## Product Advisory (PA)

**Subject:** Correction to the Renesas Product ISL71840\* Datasheet and DLA SMD

**Publication Date:** 11/11/2022

**Metalization Mask Layout**

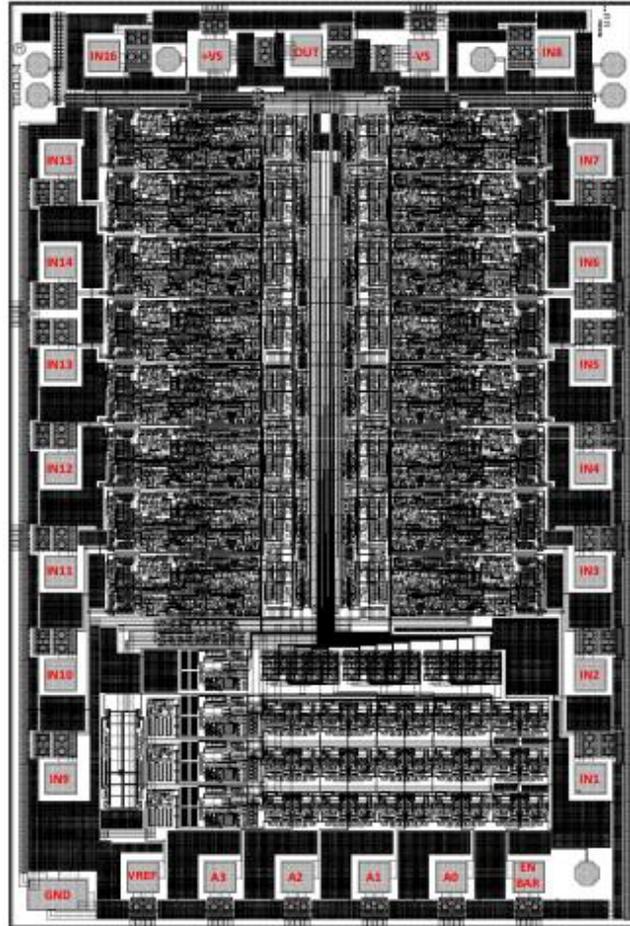
1. Update the Metallization Mask Layout diagram, correct label for pad number 18, from A4 to VREF. (Applies to both Datasheet and SMD)
2. Update "Table 3. ISL71840SEH Die Layout X-Y Coordinates". (Applies to Datasheet ONLY)
  - a. Row 2, Column 2: change from "V+" to "V-".
  - b. Row 4, Column 2: change from "V-" to "V+".
